Subject	07-11 CR-V Passenger's Airbag Inflator Kit-INSPECT BEFORE INSTALLATION-UPDATE
----------------	---

Subject: 2007-11 CR-V Front Passenger's Airbag Inflator Kit – INSPECT BEFORE INSTALLATION-**UPDATE**Yesterday, May 15th, American Honda identified a concern with the following airbag inflator kit:

Part Number	Part Description	Action
04790-SWA-407	2007-11 CR-V Front Passenger's Airbag Inflator Kit	Inspect Before Installation

GOOD

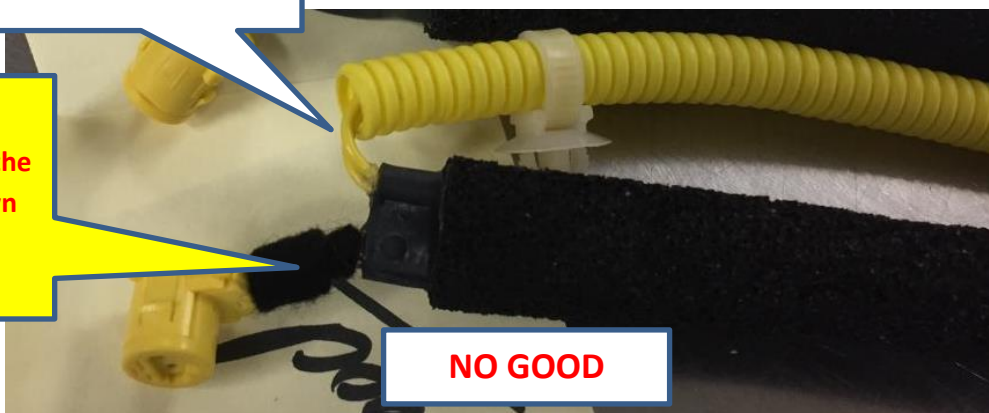
The RED wire should measure 530 mm which runs the entire length of the harness (from the 4 pin prong to the 2 pin prong at the end)

The YELLOW wire should measure 225 mm (from the 4 pin prong to the center 2 pin prong)

This is the incorrect wiring harness. The yellow wire was INCORRECTLY installed. (DO NOT USE!)

Black felt tape should not cover the red wire as shown here

- The yellow wire should measure 225mm and the red wire should be 530mm (image attached).
- The incorrect wire harness will also have a black felt tape around the red wire near the 2 pin prong that is in the center of the wire harness (image attached).

- Do **not** replace the incorrect harness with a harness from another kit; you **must** keep the incorrect harness within the inflator kit packaging that it was originally shipped.

- If the harness does not match the correct images, keep the kit separate from your other stock and email the following information to ahm_inflator_swap@ahm.honda.com with the subject line "PN 04790-SWA-407 Harness Issue":

- If the wire harness is correct, you may proceed accordingly and install the inflator kit per the applicable service
